CITY OF PORTLAND

DEPARTMENT OF PLANNING & URBAN DEVELOPMENT
INSPECTION SERVICES DIVISION

109A-B-20 Island Avenue
Cliff Island

May 28, 1987

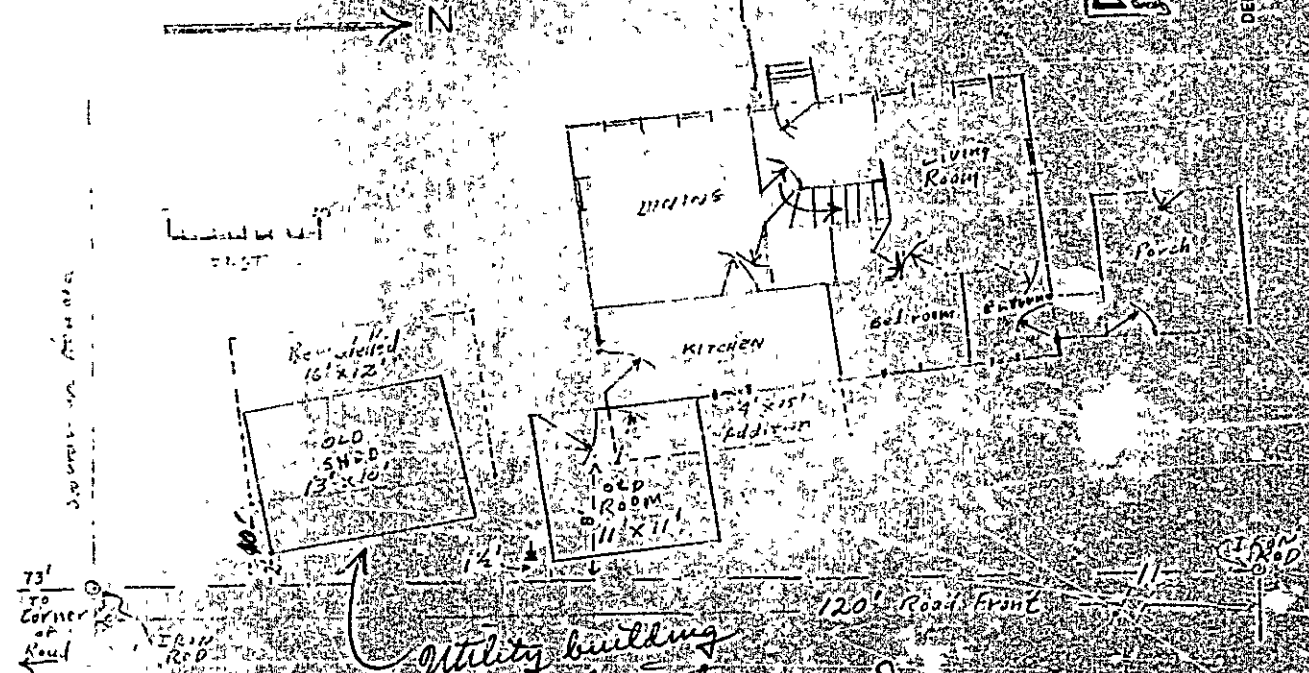
This is in response to your application for an addition to the existing building on Island Avenue, Cliff Island, overlooking Dunham's Cove. The accessory building should be placed 10 feet back from the road following removal of the existing accessory building. This is considered to be the minimum setback if the roadside is considered to be the rear of the building and the waterside is considered to be the front side.

The front and rear setbacks for the existing structure based on the current IR-1 Island Residential Zone requirements require 30 feet and so the proposed kitchen addition is not to be permitted. It may be that the addition could be placed on the dining-room frontage and then additional area might be added to the kitchen from the dining-room side in order to expand it. Please consider this possible alternative to your proposed plan.

We regret that we cannot approve the plot plan as submitted. Perhaps you may wish to revise your plan to comply with the IR-1 setbacks, or alternatively, you may wish to seek a variance from the Board of Appeals.

*Utility building only is
being removed and replaced
10' from street line in accord
with IR-1 Zone reqs.*

3 10' accessory bldg

✓ 5' from main bldg

✓ 15' from side line

2 8' for kitchen addition

Front or Rear Yard
setback: 30'

Check setbacks for F.R.-1 on Island Map
& Zoning Ordinance
Accessory bldg + Rear Yard for main bldg

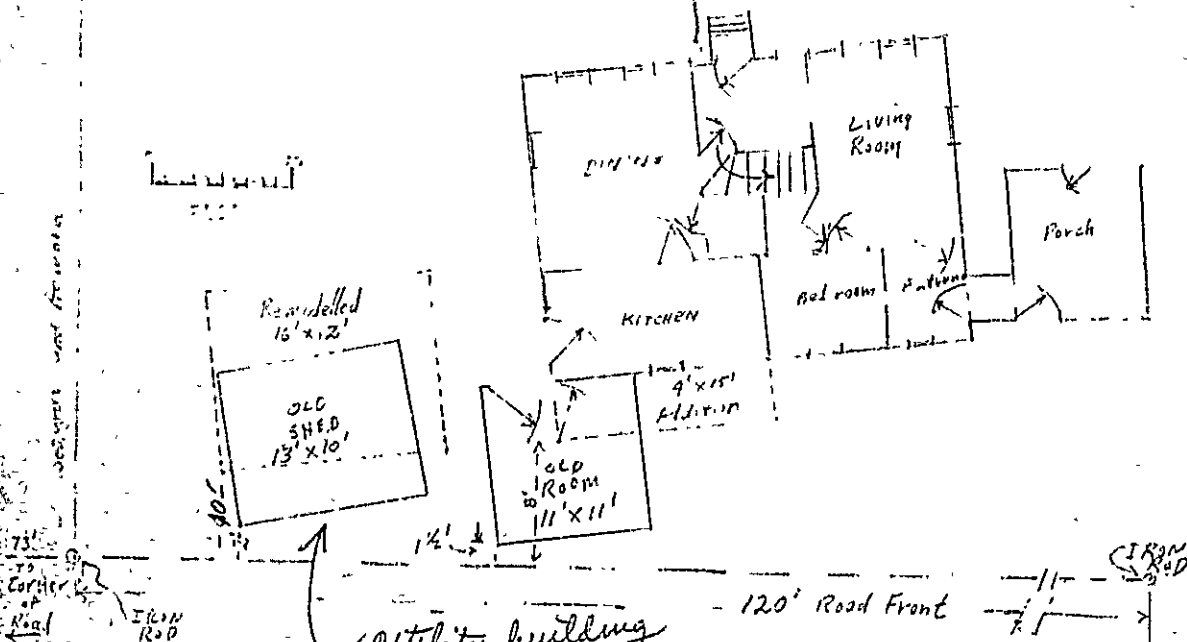
Utility building
only is being
removed and replaced
H. J. Turner June 5, 1987
